1. SUBMITTAL TYPE: (Is this a resubmittal? Yes ☐ No ☒)			
Deferred Submittal ☐	Addendum Number: 01	Revision Number:	CCD Number: Category A ☐ or B ☐
2. PROJECT INFORMATION:			
School District/Owner: San Beranrdo City USD		DSA File Number: 36 H7	
Project Name/School: Indian Springs HS - Health Center		DSA Application Number 04 123900

ADDENDUM NO. 1

Indian Springs High School – Health Center

DSA #04-123900 FILE #36-H7 RCA Project No. 1-78-50

FIRE ALARM RISER DIAGRAM

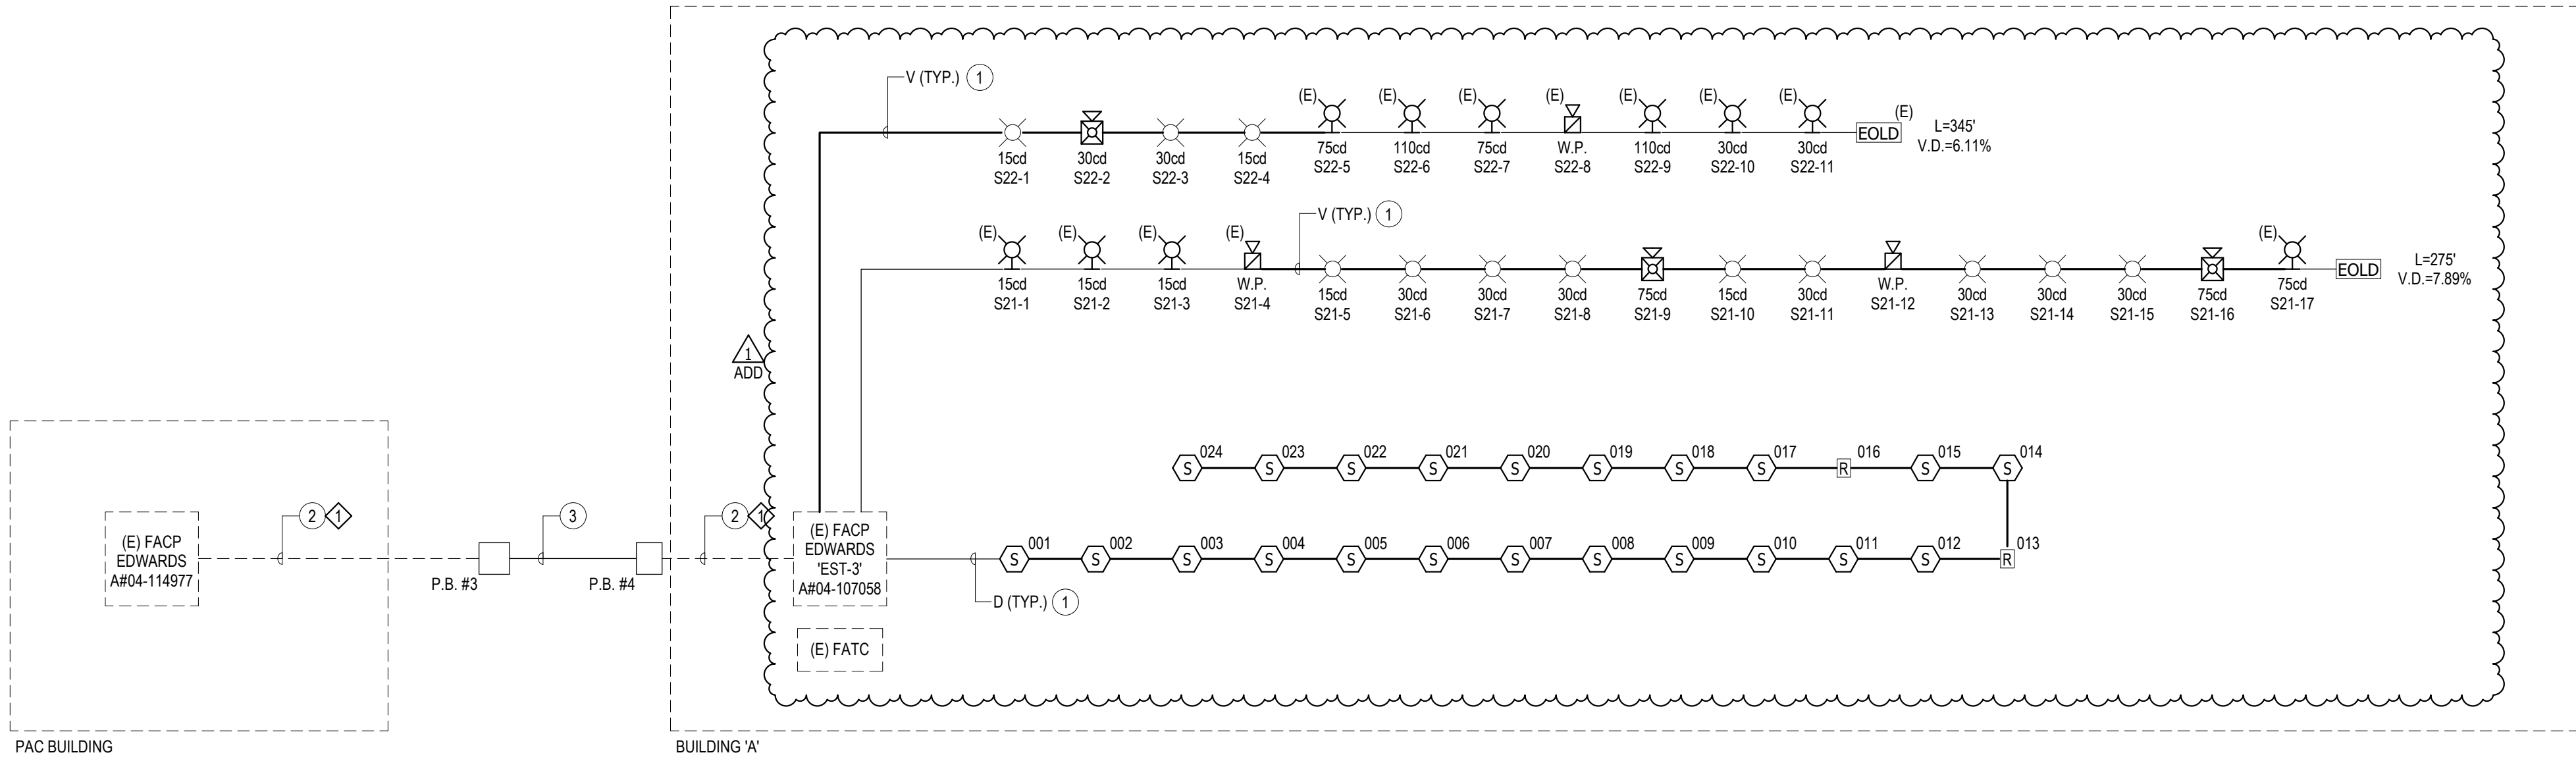
- Item No. 1.55 Reference Sheet F0-0.3 - FIRE ALARM RISER DIAGRAM
1.55.1 Replace Sheet F0-0.3 and revise per clouded areas & items listed below:
 (a) The Fire Alarm Riser Diagram has been updated to reflect the removal/addition of fire alarm devices in the revised floor plan on sheet F1-2.1

(b) The Fire Alarm Calculations have been updated to reflect the revised Fire Alarm Riser Diagram.
- Item No. 1.56 Reference Sheet F1-2.1 - FIRE ALARM REMODEL PLAN

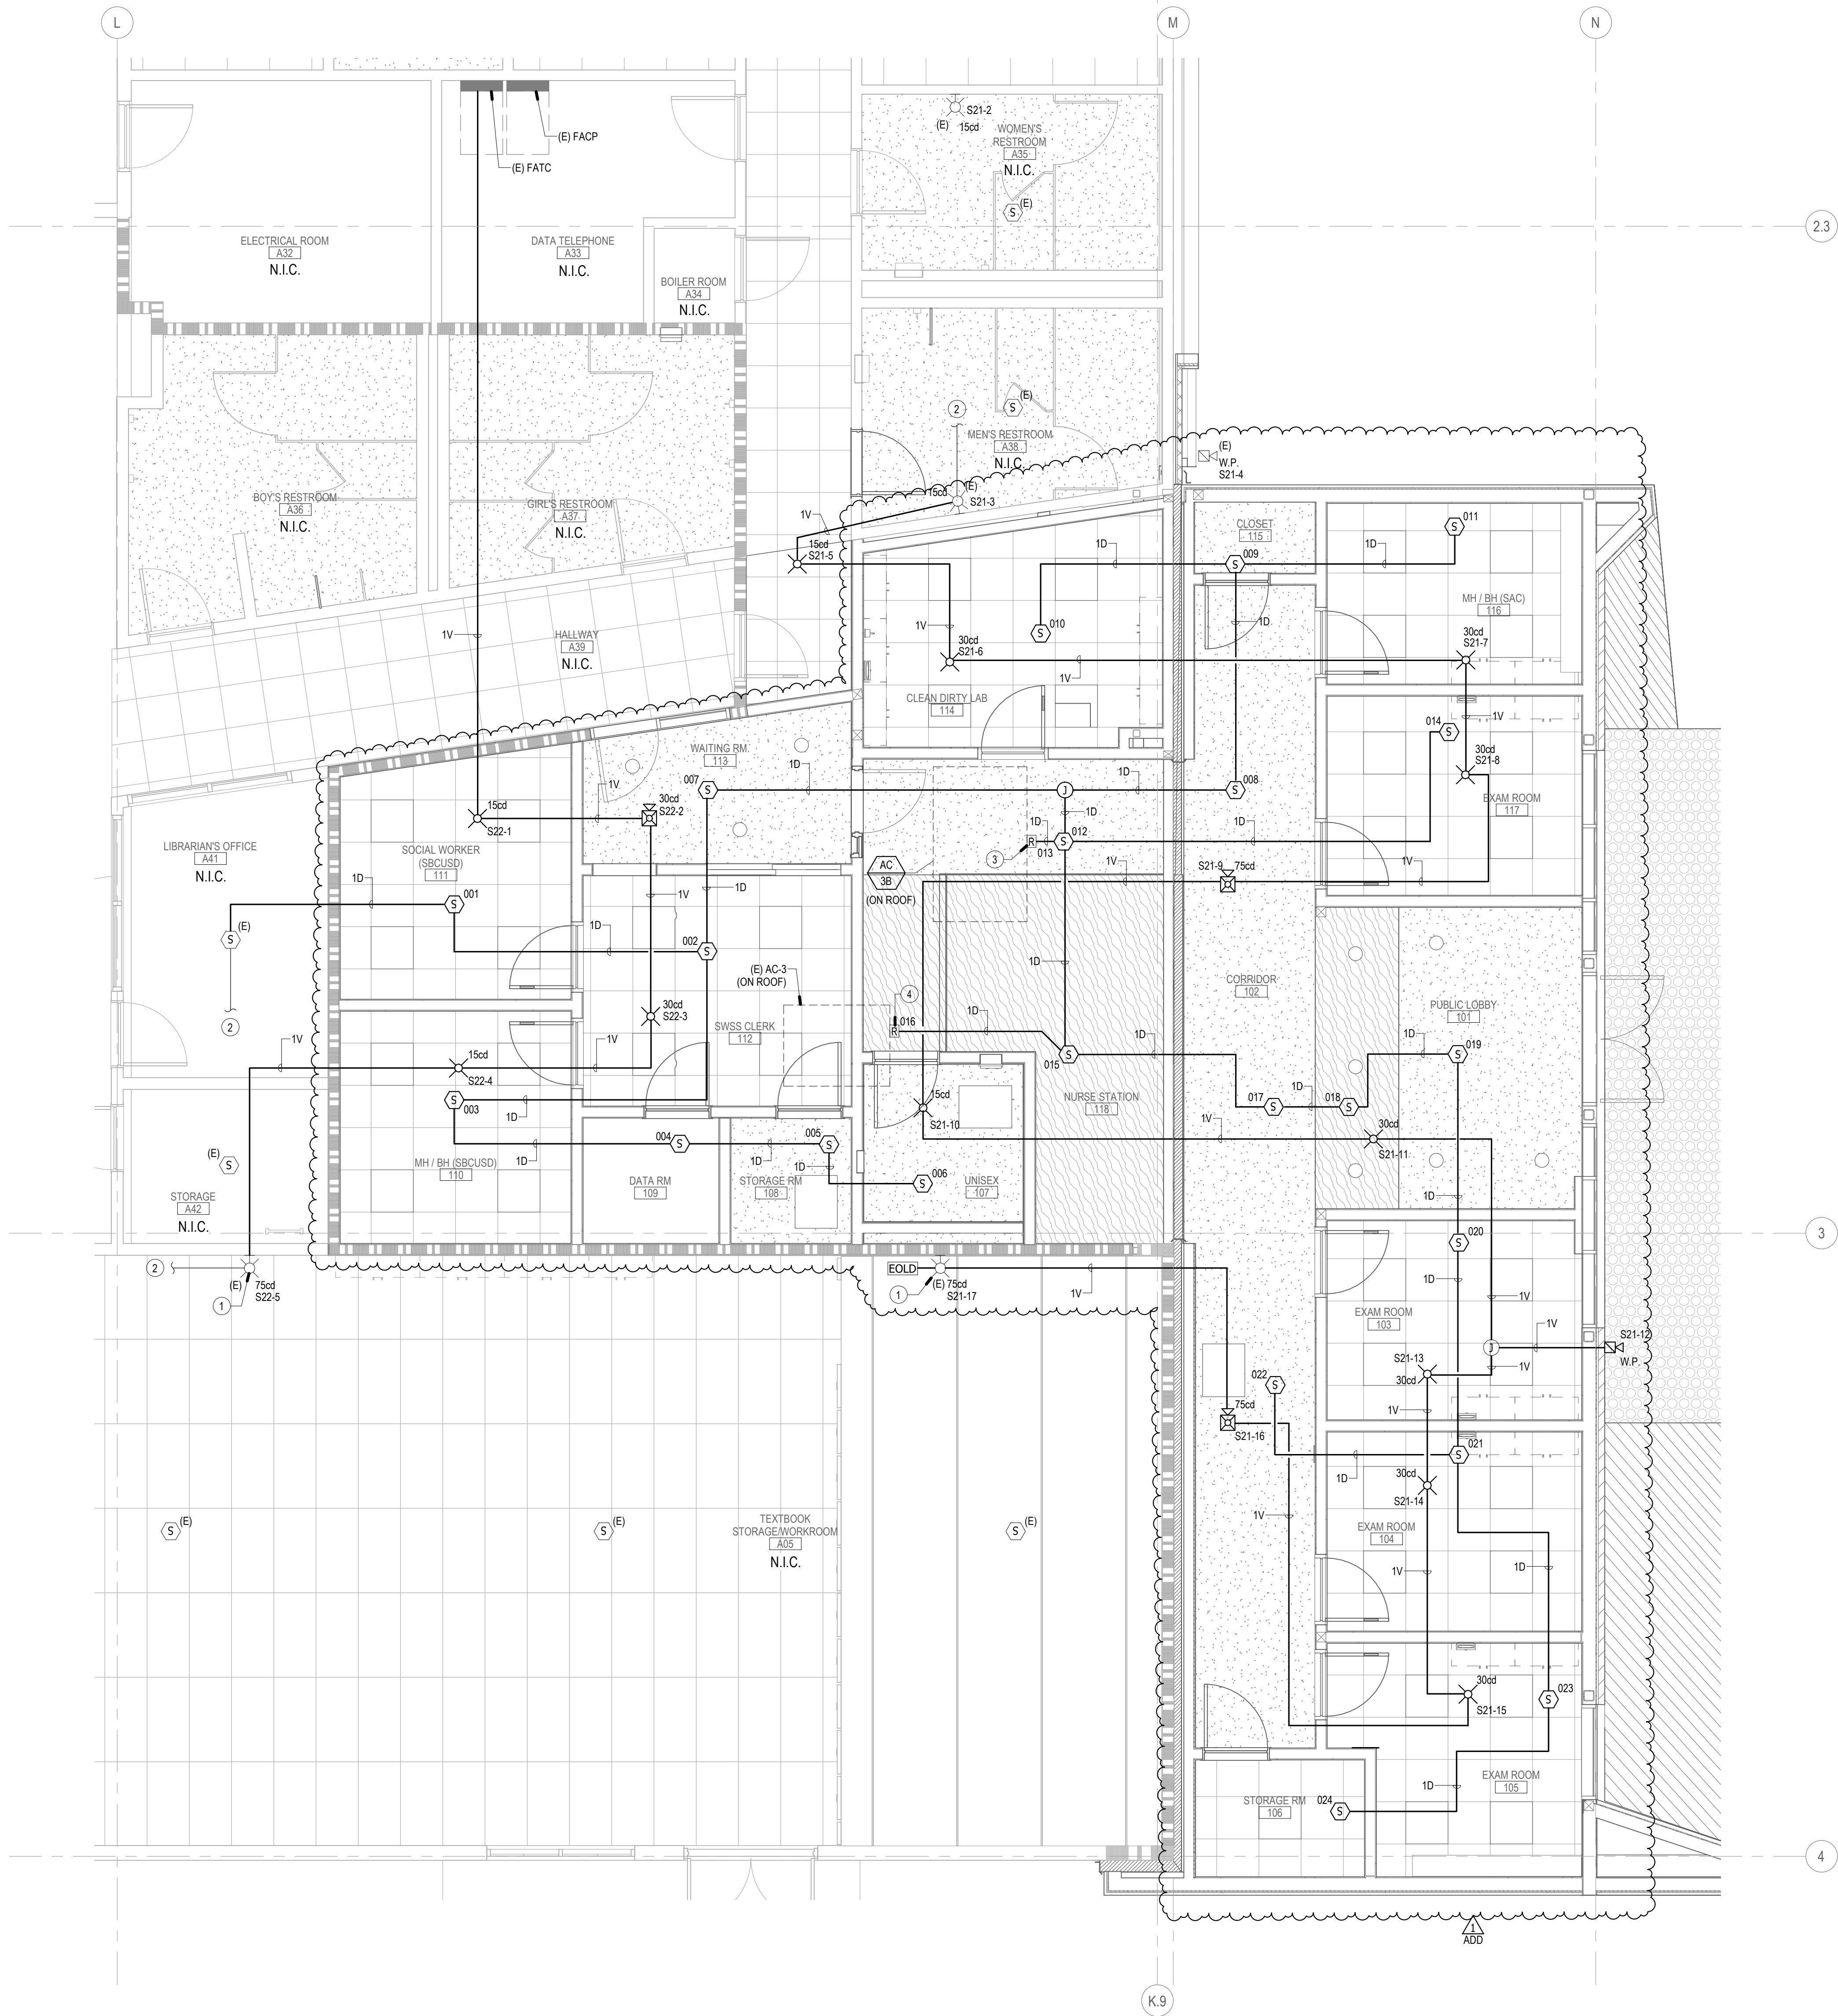
1.56.1 Replace Sheet F1-2.1 and revise per clouded areas & items listed below:
 (a) The Fire Alarm Remodel Floor Plan has been updated to reflect the revised ceiling plan layout, with the removal/addition/relocation of fire alarm devices.
